SUBJECT Port Road Reconstruction
Z621230000/0002278
: Design Study Report Revisions

**ALASKA DOT&PF PRECONSTRUCTION
DESIGN EXCEPTION/DESIGN WAIVER FORM**

Project Name: Nome Port Road Reconstruction

Project Number: Z621230000 / 0002278

PORT ROAD RECONSTRUCTION PROJECT
 Z621230000/0002278

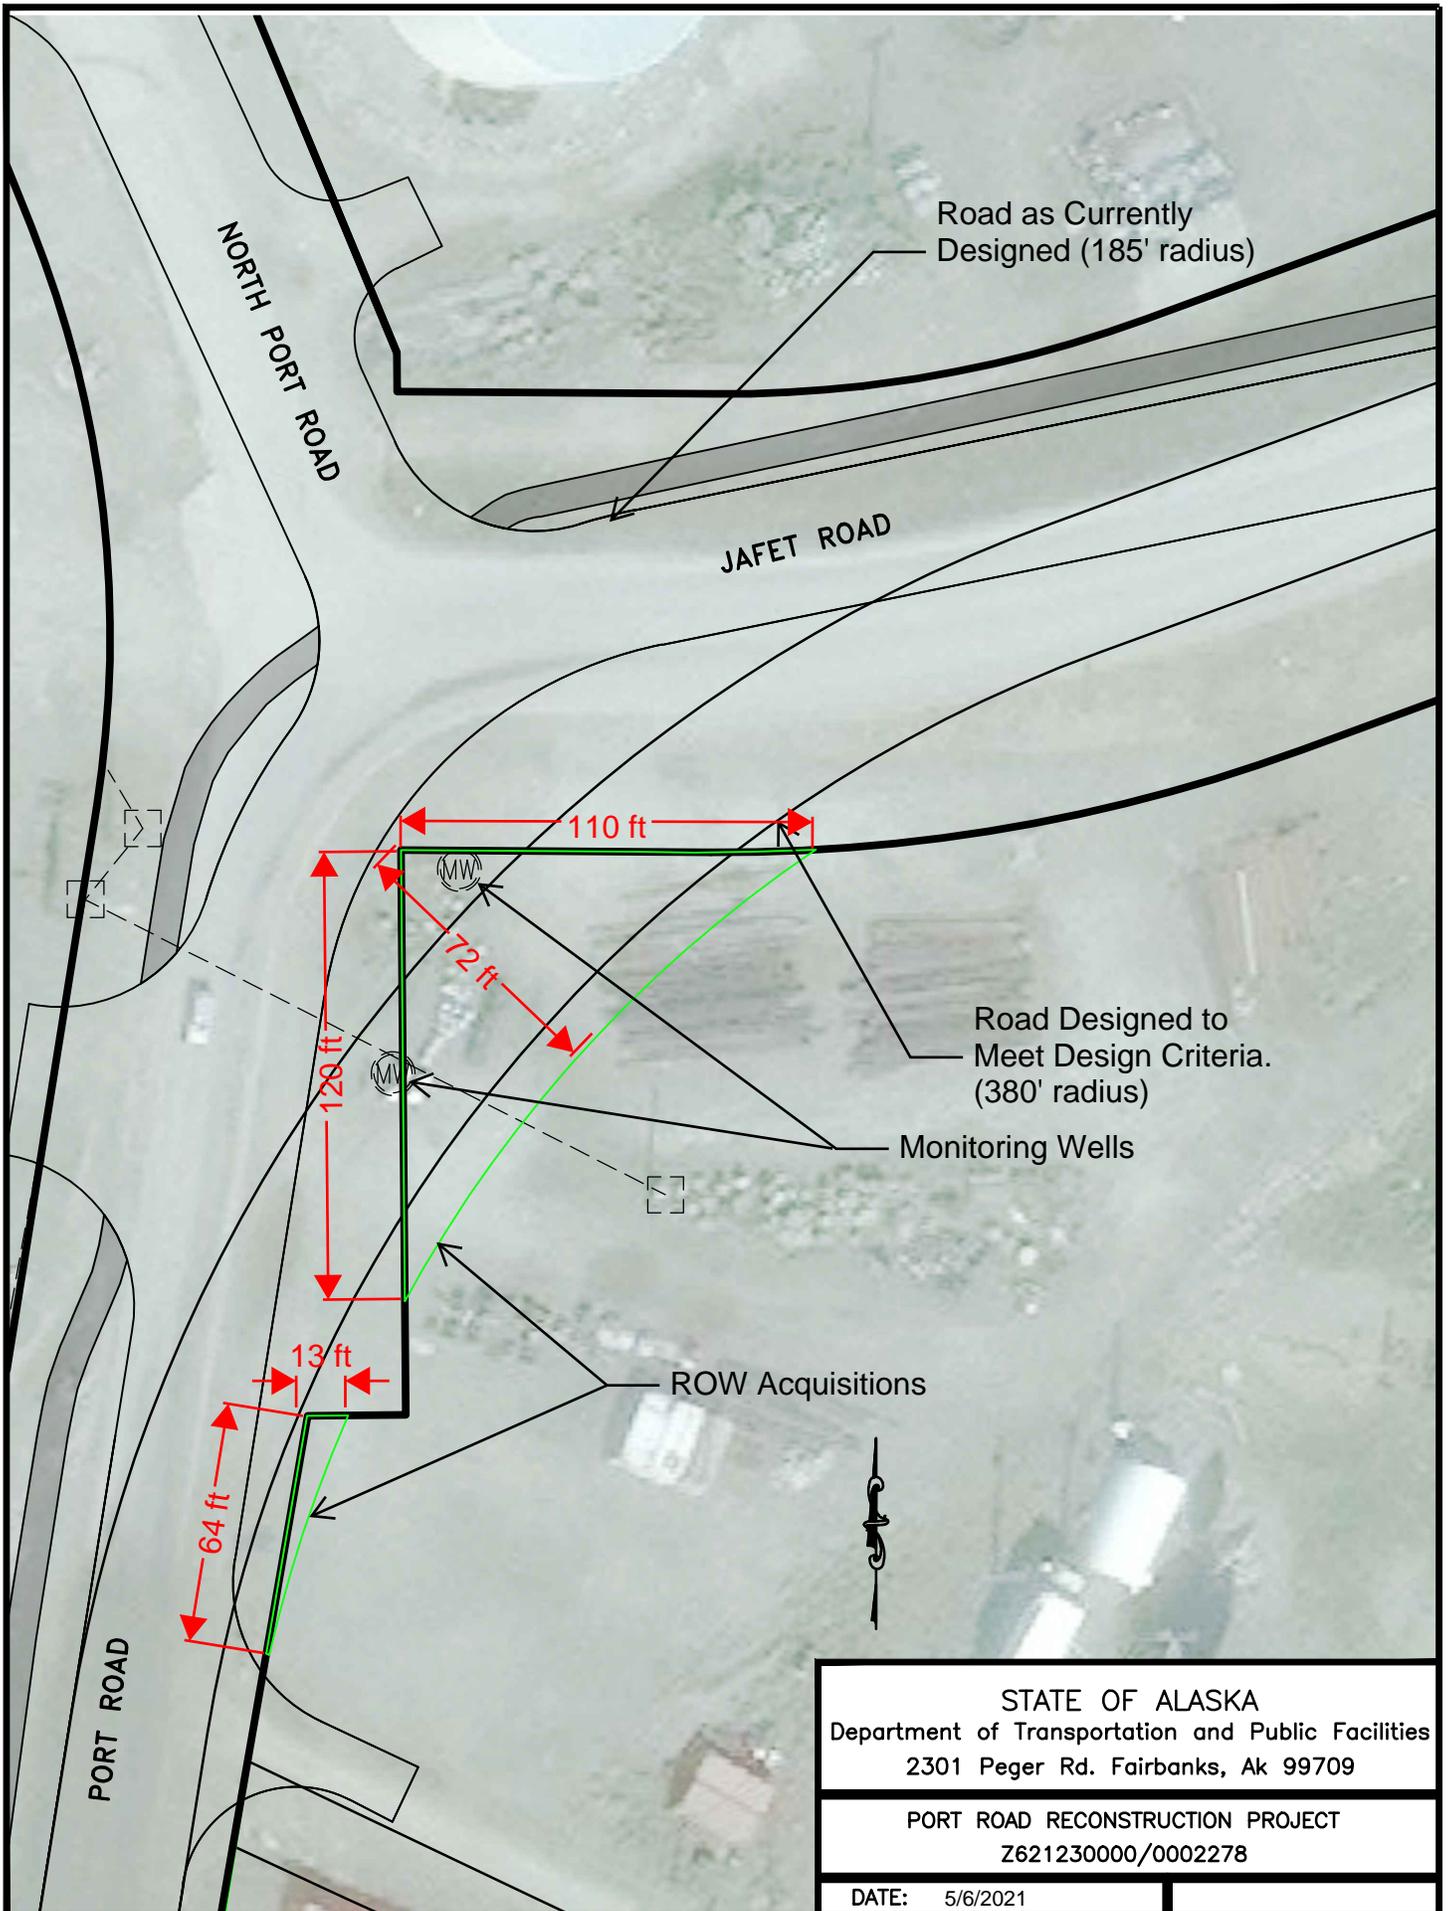
The project proposes to shift the stop control from the existing east leg (Jafet Road) to the north leg (now North Port) and construct a curve for the through movement occurring from Jafet Road to the south leg of Port Road. We adjusted the alignment of Jafet Road to the north to maximize the horizontal curve radius, but due to ROW constraints the maximum horizontal curve radius at the Port Rd/Jafet Rd intersection will only support a reduced speed of 20 miles per hour. The change would allow for slower unrestricted movement for traffic and freight and give priority movement to the heaviest traffic users.

Proposed Design Exceptions/Design Waivers Summary			
Criteria	Standard	Proposed	Location (entire project or station range)
Minimum Radius of Curvature (AK DOT Preconstruction Manual Figure 1120-1)	380 ft for 35 mph (design Speed) 185 for 25 mph (posted speed)	130 ft (Meets 20 mph curve) (115 ft is the minimum radius for 20 mph curve)	Station 31+47 to 33+06

The proposed design exception would reduce the design from a 35-mph curve with a radius of 380 feet to a 20-mph curve with a radius of 130 feet. The road speed limit is signed at 25 mph, the design exception is 5 mph below the signed speed. The exception will not affect other standards. A curve warning sign will be placed at both ends of the curve to alert users of the reduced radius. Multiple design exceptions / waivers are not being requested for this segment.

While the proposed curve is below the design speed of the roadway it will improve the safety and functionality of the intersection by providing free flow of traffic from Jafet road onto Port Road and on to the causeway and barge landing. To build a curve that meets the design criteria at this location would require acquisition of ROW with known contaminated soil conditions. The road alignments was designed to maximize the curve radius while staying within the ROW that was acquired 5 years ago for the Snake River Bridge Project.

The project cost will increase if this curve is constructed to meet design criteria of 380' radius. A curve meeting the design criteria would require the acquisition of 0.2 acres (see attached figure for 110' by 120' and 13' by 64 feet triangles) from a lot owned by the City of Nome that has been, and is currently, used as a storage yard for electrical transformers, poles and other components. The road embankment would bury two existing monitoring wells located on the site.
